Technical Comments

Comment 1: On p 19, lines 5-7, the SER states "The NRC staff notes that PSI of the overlaid DMW needs to achieve 100 percent examination coverage of the required examination volume. The NRC staff would allow the "essentially 100 percent" examination coverage for the ISI, but not for the PSI. This position is reiterated in item 13 of Section 4.0, Limitations and Conditions (p26, lines 29-32).

Figure 7-1
Inspection Requirements for Weld Overlays

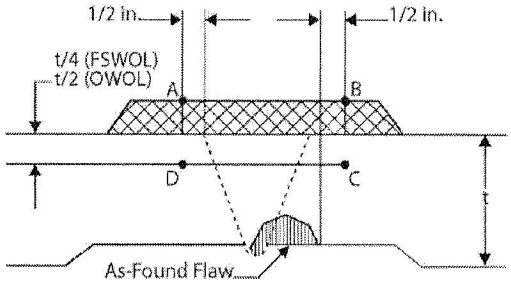
The industry does not understand the logic for requiring different examination coverage requirements for PSI versus ISI. The same examination volume applies to both of these exams (Figure 7-1b) in MRP-169, Rev. 1, reproduced below), and if there are physical restrictions that limit the ability to achieve 100 percent examination coverage (rather than "essentially 100 percent"), then those restrictions will affect both PSI and ISI. However, if this statement applies to the weld overlay acceptance examination, for which the applicable examination volume is A-B-C-D in Figure 7-1a) below, then this is consistent with the coverage requirements of Section 7.1 of MRP-169-1: "For the overlay acceptance examination, 100% of the required UT and PT exam volumes in Figure 7-1a) shall be examined. For post-overlay pre- and inservice inspections, essentially 100% (>90%) of the required exam volume in Figure 7-1b) shall be examined, but shall include no less than 100% of any PWSCC susceptible material within the exam volume."

<u>Comment 2</u>: *On p 19, lines 5-7 the SER states "The NRC staff finds that if the examination is performed from the inside surface of the DMW, a UT examination must also be performed from the outside surface of the pipe and the examination volume must satisfy Figure 7-1(b) of TR MRP-169."*

The logic for this additional requirement is also unclear. There would be no benefit to performing an examination of the standard ASME Section XI ISI examination volume (i.e. inner 1/3 of the DMW wall thickness) from the inside surface if there is also a requirement to perform an examination from the outside surface of the Figure 7-1b) examination volume. Performing the inside surface examination, as specified in MRP-169-1, with additional demonstration or qualification on weld overlay mockups to demonstrate that ID connected flaws are still detectable after application of the overlay, will ensure that there are no ID connected flaws in the PWSCC susceptible material that could propagate to the point that they would violate the overlay design basis.
